1973 F6-B

PARTS DIAGRAM

SWING ARM/SHOCK ABSORBERS

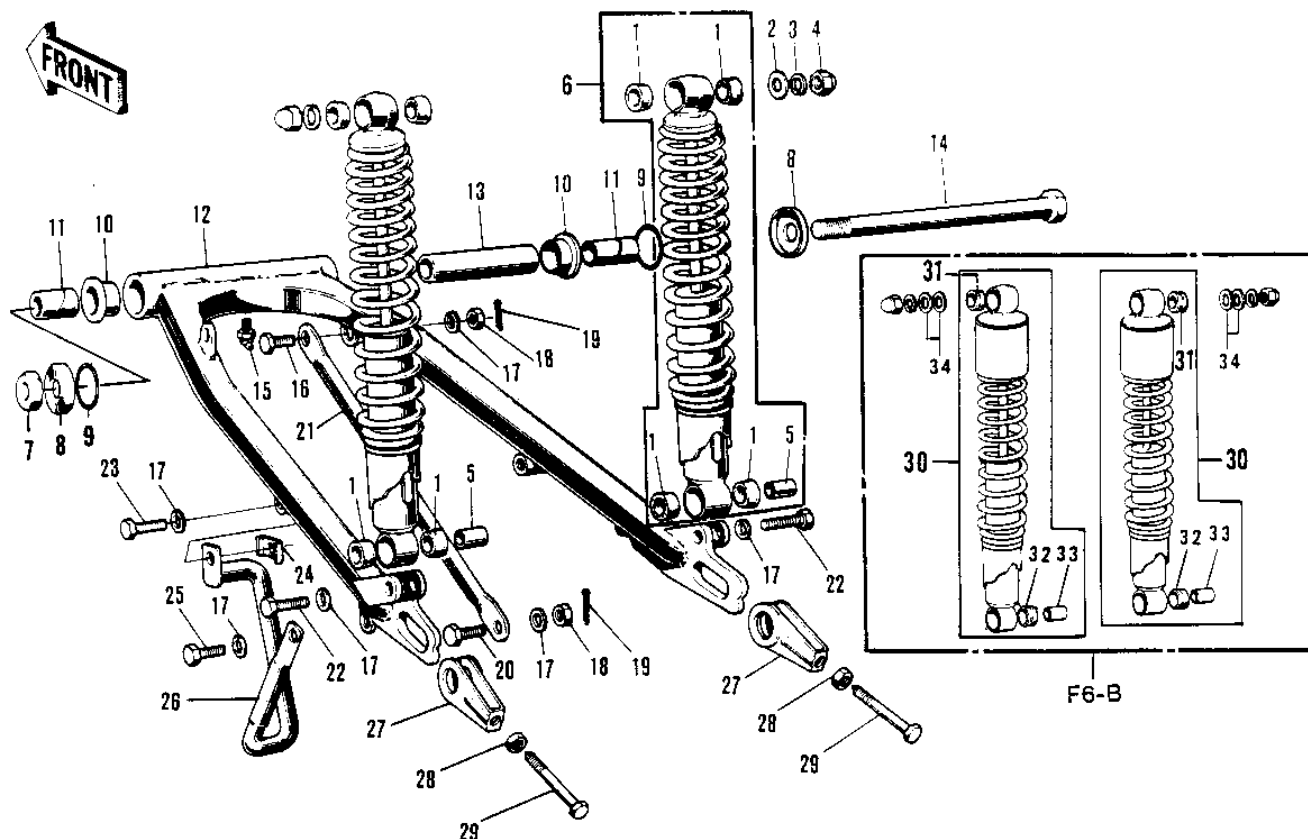
Ref. No. 27, Chain Adjuster		
	OLD	NEW
	1.6 mm 15.2 mm 	3.2 mm 13.7 mm
Chain Adjuster	33041-041	33041-048
Collar	42032-027	42032-036
Frame No.	~13329	13330~
Interchange?	Use new parts as a set in place of old parts.
